Declaration

Model Information:	
Applicant's Name:	BYD Precision Manufacture Co., Ltd.
Applicant's Business Address:	No.3001, Baohe Road, Baolong Industrial, Longgang, Shenzhen, 518116, P.R.China
Model Name:	T02D
HW version:	MP
SW version:	YTP802A110830

The main differences conducted to 2nd source as below:

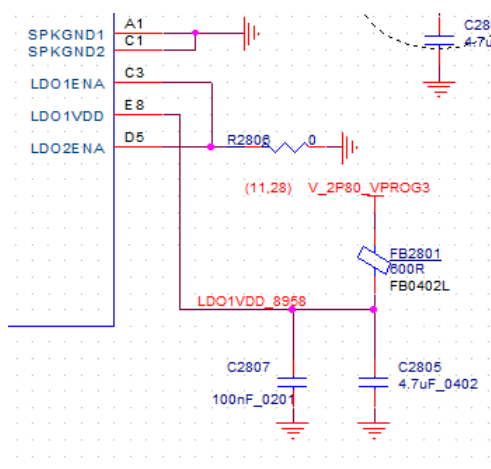
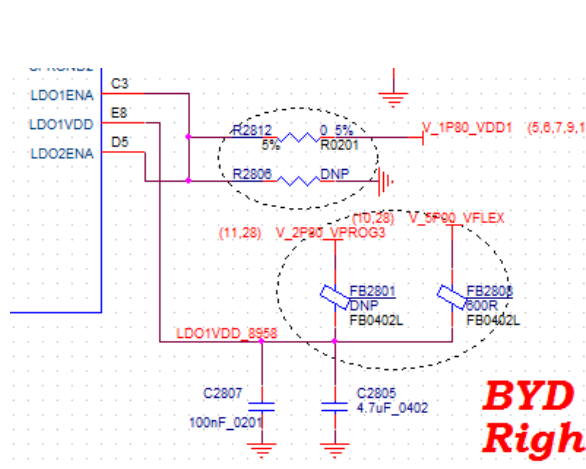
1、AVDD1&DCVDD Changed to internal LDO to improve power consumption and resolve earphone detect issue.

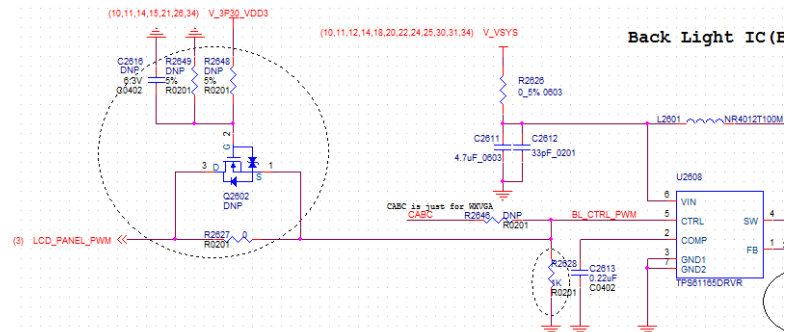
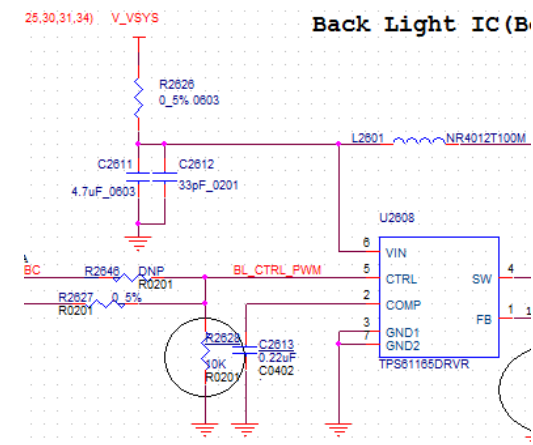
2、Change R2628 from 10K to 1K for LCD flicker while power on. And add reserve circuit to avoid LCD flick issue if the current solution is not OK.

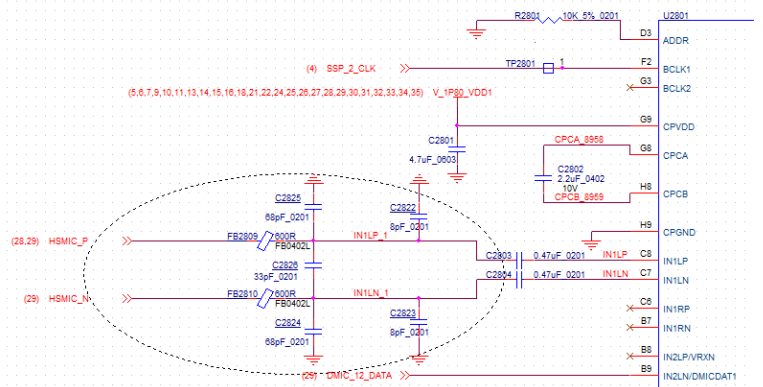
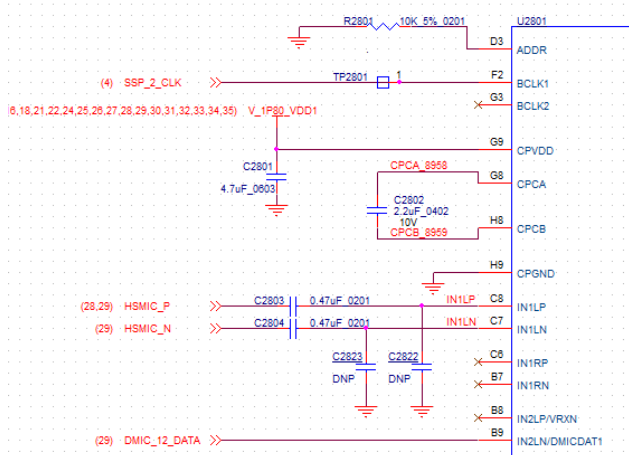
3、ADD C2822,C2823,C2824,C2825,C2826,FB2809,FB2810 to filter TDMA Noise.

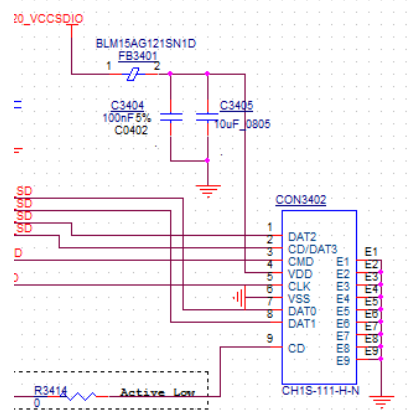
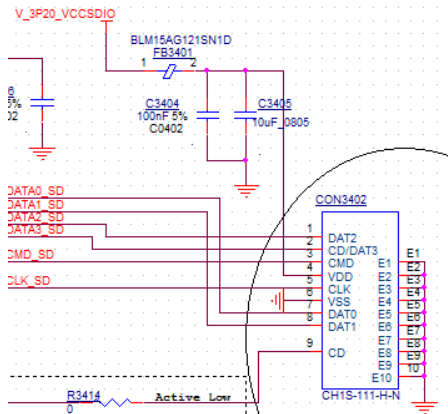
4、Delete pin E10,because this pin is easily short to SD card's frame GND and after del E10 pin it will not influence the reliability.
